Huntlee – Stage 1 MP10_0137 Modification 20 – Response to Submissions

Ethos Urban acts on behalf of Huntlee Pty Ltd regarding the section 4.55(2) Modification Application (MOD 20) to Project Approval MP10_0137, relating to the Huntlee New Town, Branxton. The purpose of this letter is to provide a Response to Submission (RTS) addressing the issues raised by the Department of Planning and Environment (DPE), other government agencies and public submissions received during the exhibition of the modification. The modification was publicly exhibited between 6 April 2022 and 19 April 2022. The submissions received are outlined below:

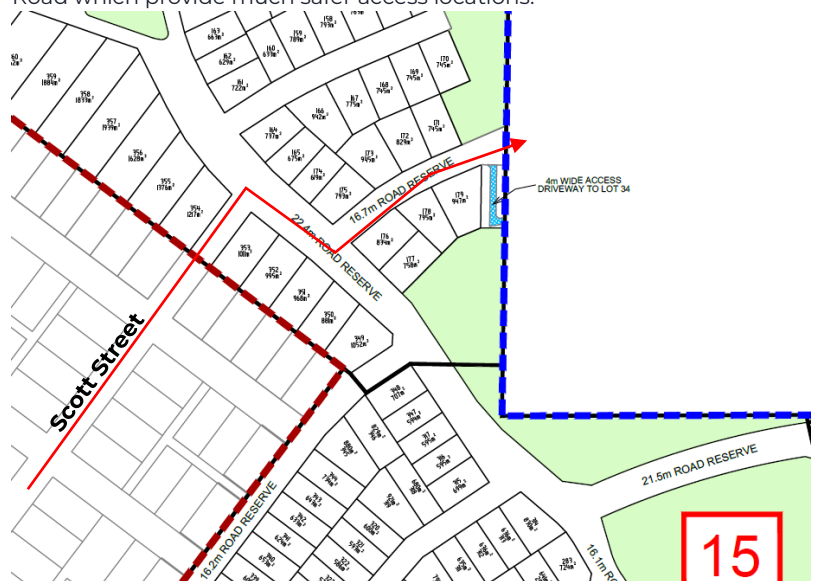
A) The constructed longsection of the road adjacent to the southern boundary of Lot 34 was raised significantly, as compared to the longsection originally approved, necessitating a retaining wall. This has been constructed along the southern boundary of Lot 34, in some cases over 2 meters high. This has prevented the connectivity shown in approved stage 1 concept plan.

The road referred to crosses a natural creek line where an online detention basin is located. In order for this detention basin to operate as required to avoid an increase in peak flows across Lot 34, it must be elevated to create the storage within the creek line and ensure that the road level is above the 1:100 year flood line plus appropriate freeboard.

Connectivity would still be possible from Lot 34 - this would simply require engineering solutions such as fill and retaining walls to create the road connection. The owner of Lot 34 (Mr Dennis Beddall) has been previously contacted by Huntlee in regards to allowing batters into the land to avoid the need for retaining walls along the boundary (Stage 7, along the southern edge of Triton Boulevard) and to enable future access into Lot 34, however this option was declined.

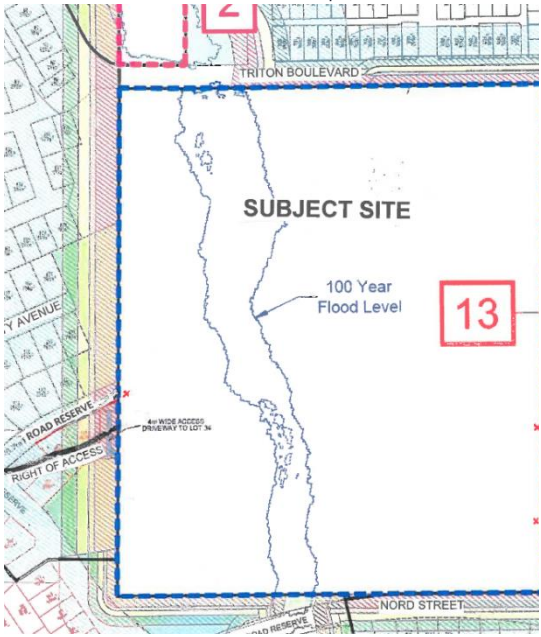
B) On the western boundary of Lot 34 roads have been terminated and WQCP approved which will prevent the connectivity as shown in the approved Stage 1 Concept Plan. This has been done without recognition of the easement for access and service connections from Lot 34 to existing Scott Street in North Rothbury. I notice the road hierarchy plan for Mod 20, shows relocated access for Lot 34, which does not join Scott Street. I can find no discussion of this, so don't know if this is assumed to be approved by referencing the plan in any approval. This appears to have been the case in the past where road connectivity has been deleted in plans modified from the approved Stage 1 Concept Plan without any written discussion in the associated statement of effects.

Condition E8 requires and ensures that access to Lot 34 will be maintained at all times, and if adjustment to the existing right of access is required in order to provide access over a new public road, this will be discussed with the owner of Lot 34. The new proposed access to Lot 34 is shown on Modification 20, and Huntlee has not received an objection to this access location from the owner of Lot 34.
